Access Compliance Report Public Rights-of-Way (Curb Ramps)

Main Street: O_NEILL_DR Cross Street: ETON_PL Location: S

ADA ID: RPRK211027115828 Ramp Type: Type 6 - Directional 1 Initial Pass/Fail: Fail Overall Compliance: No Severity Score: 45

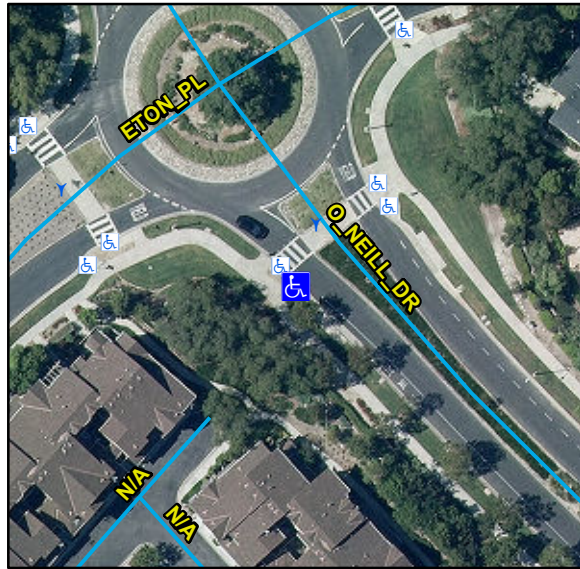
R204.3, R304.2.2, R304.5.3, STD 1115

Compliance	Description	Data	Compliance	Description	Data
N/A	Ramp Length (in)	68	N/A	Flare Type LT	
Yes	Ramp Width (in)	48			N/A
No	Ramp Run Slope (%)	9.1	N/A	Flare Slope LT (%)	N/A
No	Ramp Cross Slope (%)	9	N/A	Flare Traversable LT	N/A
N/A	Grade Break	N/A	N/A	Flare Type RT	
N/A	Grade Break Slope (%)	N/A			N/A
N/A	Grade Break Cross Slope (%)	N/A	N/A	Flare Slope RT (%)	N/A
	Addl Para Ramp Left?	No	N/A	Flare Traversable RT	N/A
	Addl Para Ramp Right?	No	N/A	DWS Provided	N/A
N/A	Landing Present	N/A	N/A	DWS Contrast	N/A
N/A	Landing Length (in)	N/A	N/A	DWS Length (in)	N/A
N/A	Landing Width (in)	N/A	N/A	DWS Full Width	N/A
N/A	Landing Run Slope (%)	N/A		DWS Offset Type	N/A
N/A	Landing Cross Slope (%)	N/A	N/A	DWS Left Offset (in)	N/A
N/A	Landing Movement Obstructed?	N/A	N/A	DWS Right Offset (in)	N/A
	Landing Movement Type	N/A			
N/A	Landing Shared	N/A			
N/A	Marked Crosswalk 1	No	N/A	Clear Space	N/A
	Crossing 1 Direction	SE	N/A	Clear Space To Crosswalk (in)	N/A

Remove & Replace Entire Ramp.
